EMISSIONS RECALL #617 - OXYGEN SENSOR & CAT. CONV.

EMISSIONS RECALL #617 - OXYGEN SENSOR AND CATALYTIC CONVERTER

Model(s): 1989 and 1990 Jeep Cherokee (XJ), Comanche (MJ) and Wrangler (YJ) Vehicles Equipped With a 2.5L Engine and a Federal Emission Control System and Built After November 27, 1988
Bulletin No.: 617
Date: May, 1995

Fig. 1: Oxygen Sensor Location

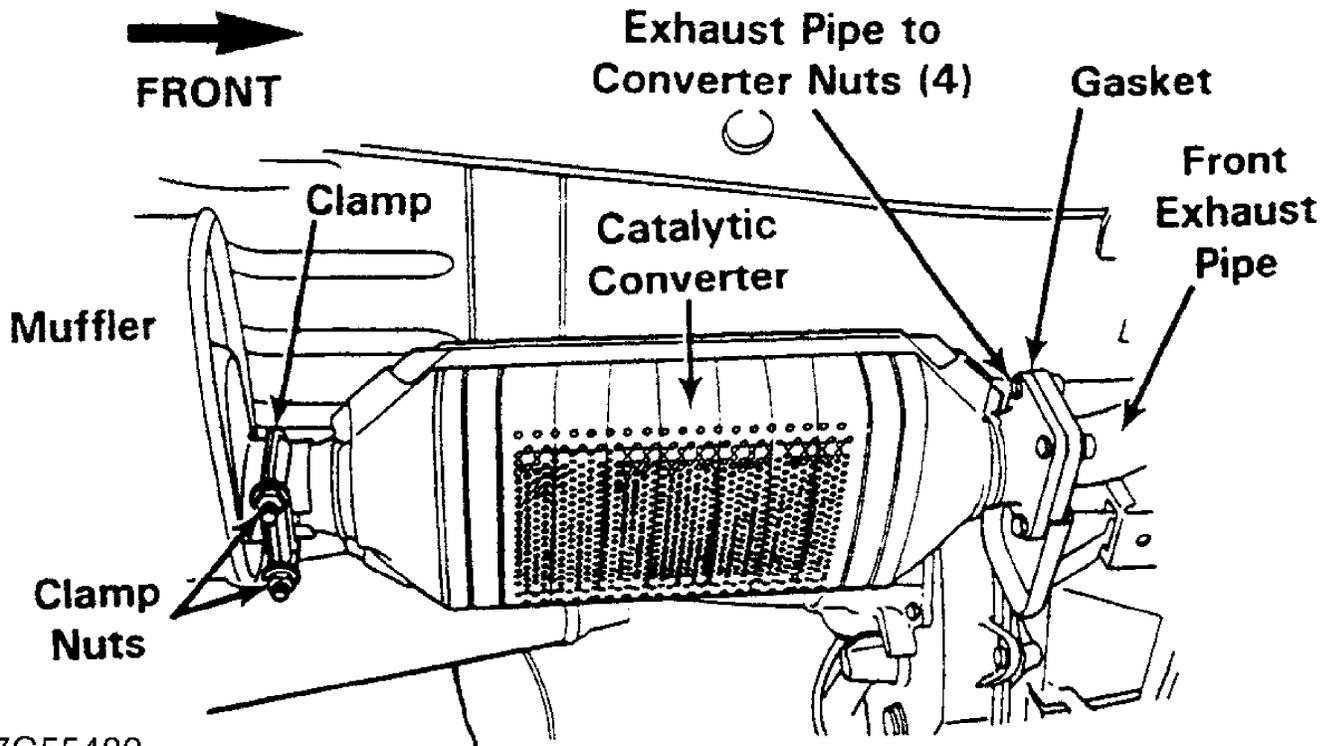
1. Locate the oxygen sensor in the exhaust manifold as shown in Fig. 1.
2. Disconnect the oxygen sensor electrical connector.
3. Remove the oxygen sensor.
4. Clean the exhaust manifold threads using a thread chaser.

5. Install provided oxygen sensor. Tighten to 22 ft-lbs (30 N-m)
6. Connect oxygen sensor electrical connector.
